febiEXAKT

Chain Tensioner

febi no. 26751

to fit
Mercedes-Benz M271 engines

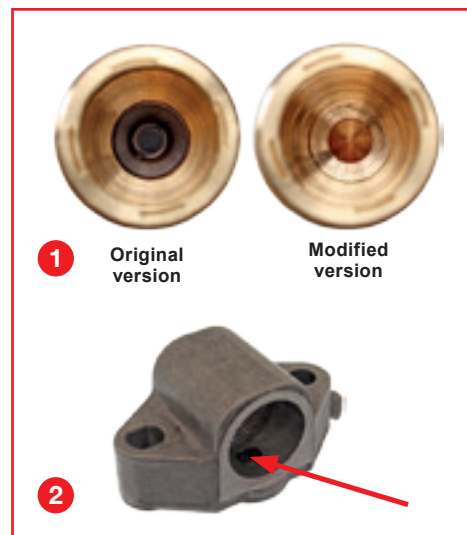
The manufacturer has modified the design of the chain tensioner. The version of the chain tensioner originally fitted (Repl. no. 271 050 04 11) has a non-return valve. In the new modified version (Repl. no. 271 050 06 11, the non-return valve has been removed (see Fig. 1).

The chain tensioner is screwed into the bracket which incorporates a non-return valve (see Fig. 2). This valve controls the volume of oil so that the piston of the chain tensioner is constantly supported by the oil pressure should the oil pressure fluctuate.

If the non-return valve in the bracket does not work correctly, the oil is always able to flow back again. As a result, the chain tensioner cannot tension the chain correctly even though the chain tensioner has been refitted. This can lead to engine damage, especially when starting up and under heavy load.

To prevent the problem described above, febi bilstein recommends that the bracket be replaced as well when the chain tensioner is exchanged for the new version. febi bilstein offers two kits (febi 40953 and febi 40954) which include the bracket with integrated non-return valve.
